MAS003863 RU 23-69

# Rapid Update 681

## Granturismo – Front Wiring Repositioning

DATE: DECEMBER 5 2023

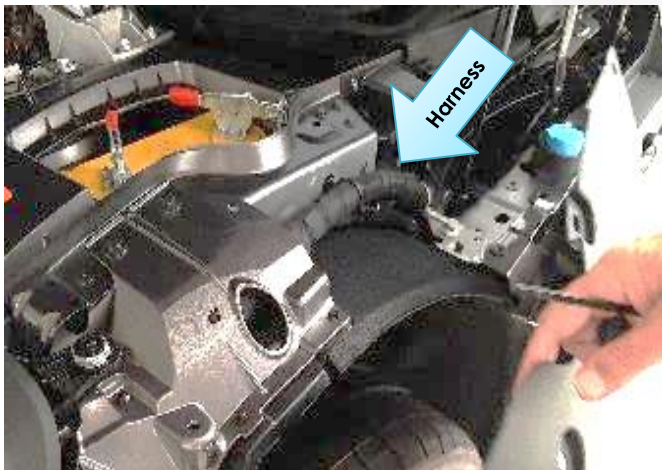
4. Locate the wiring harness underneath the front fender cover and inspect the entire circumference of the wiring harness for damage or abrasions, especially the area where the harness is routed between two screw fasteners.

**NOTE:** Although no damage is expected of the wiring harness, continue and carry out the inspection **as a precaution.**

- **OK** ▶ No damage or abrasions to the harness is found. Continue with the cable tie install **Step 7**.
- **NOT OK** ▶ Wire wrap shows signs of damage, unwrap the electrical tape of the suspected area and inspect for signs of damage to the individual wires.

6. If no damage to the individual wires is found, re-wrap the harness using electrical tape similar to factory (e.g., Tesa 51036) and proceed to **Step 7 (Cable tie installation)**.

**Cable tie installation**

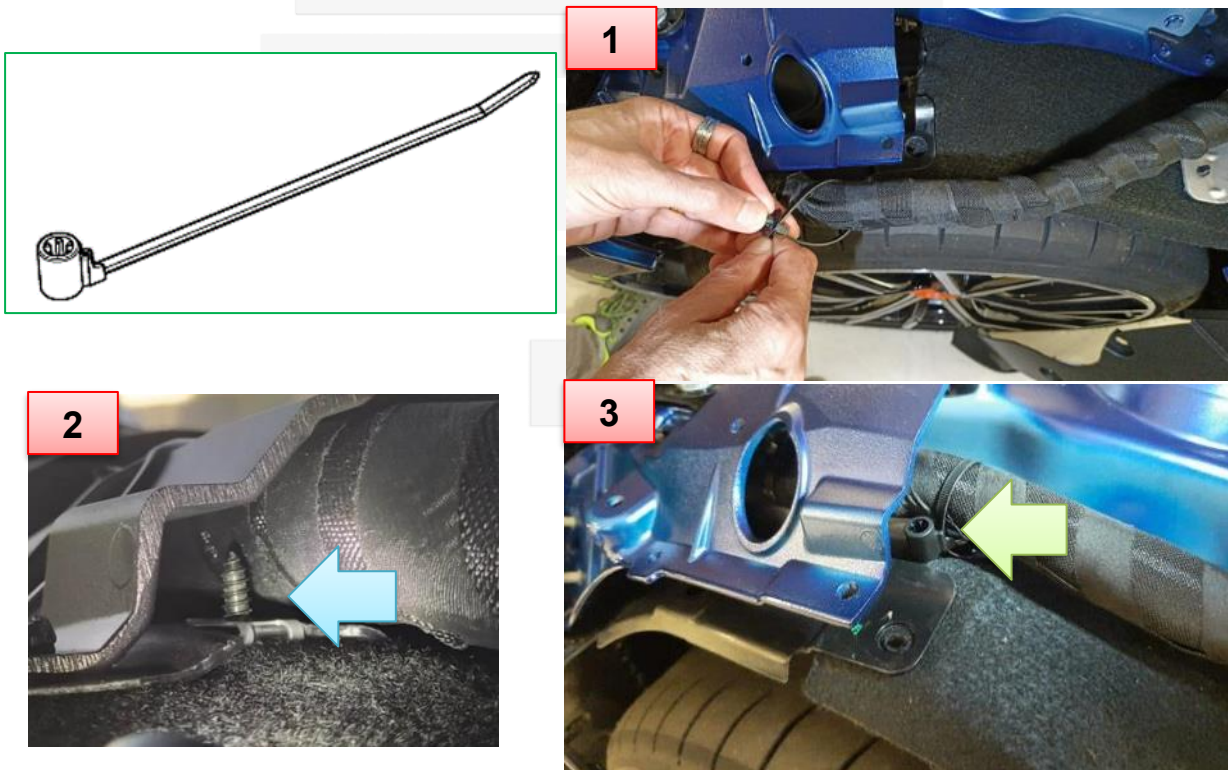
This action is necessary because there may be possible interference between the front fender well screws and a wiring harness that is positioned above the wheel arch. Although the integrity of the wiring is guaranteed by a double layer of anti-cut sheath which protects the harness in the event of interference with one or both screws, it is still necessary to proceed with the rework to ensure harness integrity.

7. Secure the harness with a new "screw-hole type cable tie" and install it as shown below:  
**(1) IMPORTANT! BEFORE TIGHTENING THE CABLE TIE:** Make sure the cable tie is positioned and aligned with the outermost screw avoiding positioning mistakes **(2)**. Once aligned, tighten and secure the cable tie to the screw **(3)**.
